# **Darling Harbour Live Hotel**

## **SSD 13\_6116**

Submission to NSW Department of Planning and Infrastructure  
4 November 2013

**Figure 6. Interface between approved Convention Centre and proposed hotel**  
Source: Department of Planning's PPP DA Assessment Report

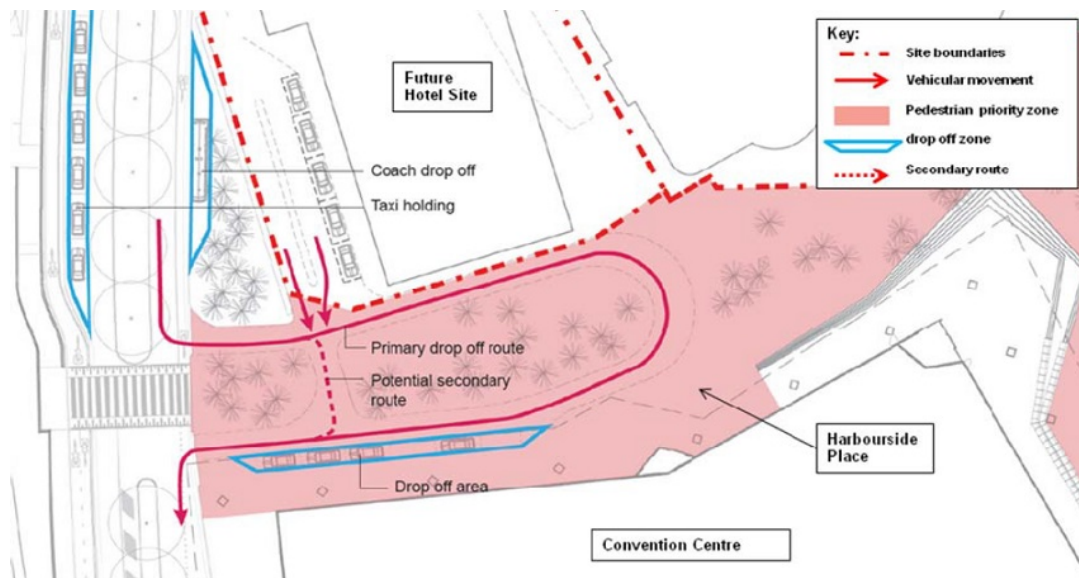
The vehicular circulation around the proposed hotel makes the area a large roundabout. The boundaries of the site are dominated and prioritised by vehicular movements.

The City's earlier submission to the PPP DA recommended that pedestrians be given greater priority in the interface between the Convention Centre and the proposed hotel by excluding vehicles in the round. However, a vehicle circulation plaza was approved. The proposed hotel relies on the plaza for vehicle drop off and pick up to the proposed porte-cochere.

The City's view is that the Harbourside Place design is unfortunate. Whilst the Convention Centre drop-off may have been approved, the case for increased vehicles from the hotel in what will be a very strong pedestrian connection is not appropriate. This is further reinforced when a porte-cochere accessed from a slip lane off Darling Drive is available.

Key issues diminishing the pedestrian amenity are:

- **Porte-cochere** – the proximity of the entry and exit either side of the pedestrian crossing impedes safety and security
- **Shared zone** – the shared way becomes dominated by cars due to the lack of active frontages and is unlikely to be used heavily by pedestrians.

#### **Recommendation 2**

Prioritise pedestrian movements in 'Harbourside Place' by relocating the porte-cochere along Darling Drive and restricting vehicle movements to a slip lane into the site rather than turning facility, as recommended in the City of Sydney submission to the PPP DA.

**Figure 8. Internal corridors should extend to the exterior of the building for light and ventilation**  
Source: Proponent SSD Application

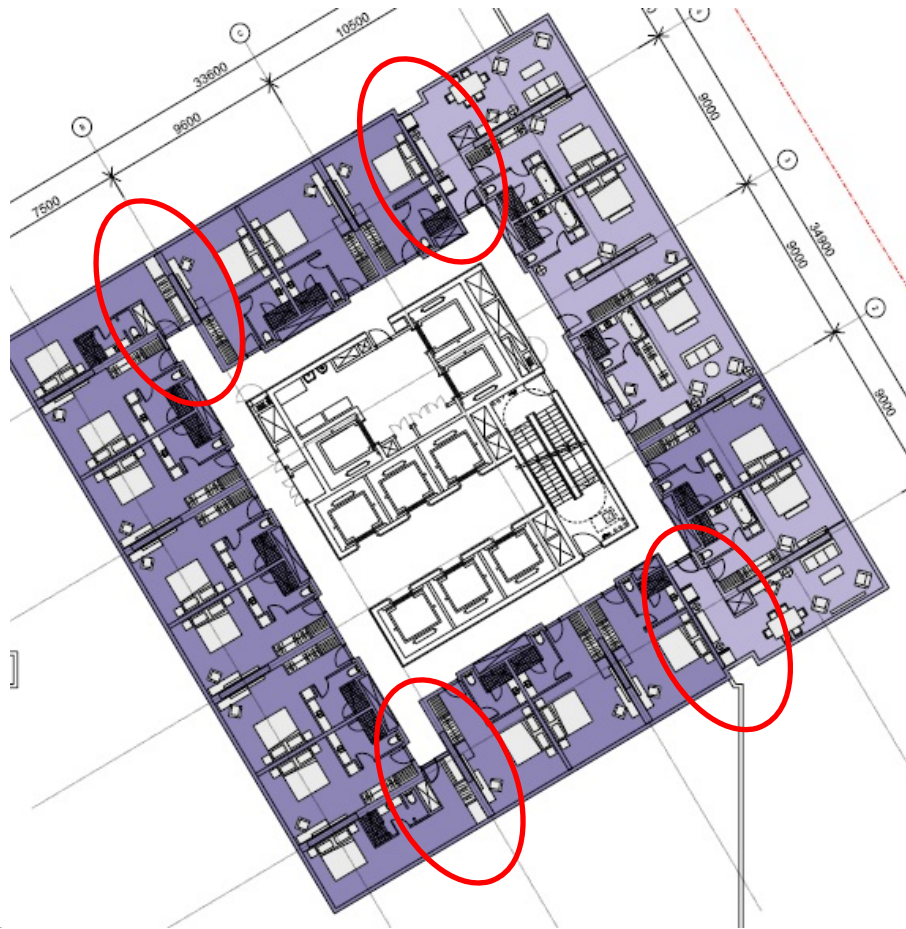
Feedback given to the Proponents in January 2013 included the City desire for the internal hotel corridors to extend out to the building face to allow natural ventilation (and therefore reduce mechanical heating and cooling), natural light, a pleasing internal outlook and greater external articulation. The internal layout is capable of augmentation to open the lobbies to the exterior.

#### **Recommendation 5**

Extend the internal corridors of the hotel levels to the edge of the building.

**Figure 9. Recommended adjustment to security room for surveillance of the loading docks**  
Source: Proponent SSD Application

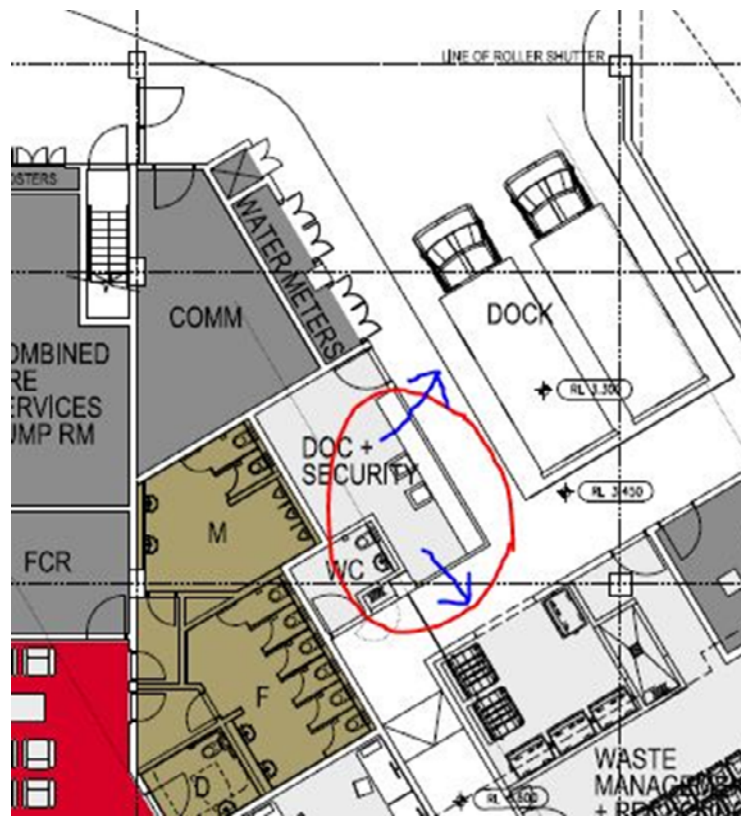
- the loading dock grill to be automated and have open (transparent) roller doors with warning signage and camera surveillance
- help points to be installed in the goods lift lobbies at all levels
- toughened glass to be incorporated in goods lift doors for eye level surveillance of lift or lobby/level approaches (subject to BCA, fire or other regulations)
- surveillance from the security room into the dock and circulation corridor. This would mean removing/remodelling the cupboard/wall along the dock wall to allow for a surveillance window to be inserted as well as a window or glass panel inserted into the wall along the circulation corridor (see Figure 9).

#### **Recommendation 10**

Detailed design of the loading docks and security room should reinforce surveillance opportunities.
